Technical Service Bulletin:
TSB180043

New Lubricating Oil Filter Head and Lubricating Oil Cooler Cover Gasket

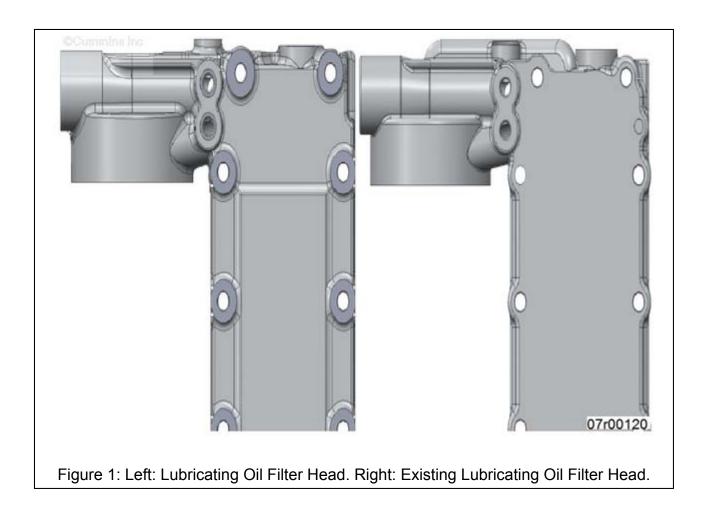
- A new lubricating oil filter head and lubricating oil cooler cover gasket are available.
- Lubricating oil filter head increases sealing flange and front wall thickness.
- Lubricating oil cooler cover gasket coating material was changed and embossments were added around sealing perimeter.

- New lubricating oil filter head can be identified by added capscrew machined bosses (see Figure 1).
- New lubricating oil cooler cover gasket can be identified by embossments around sealing perimeter (see Figure 2).
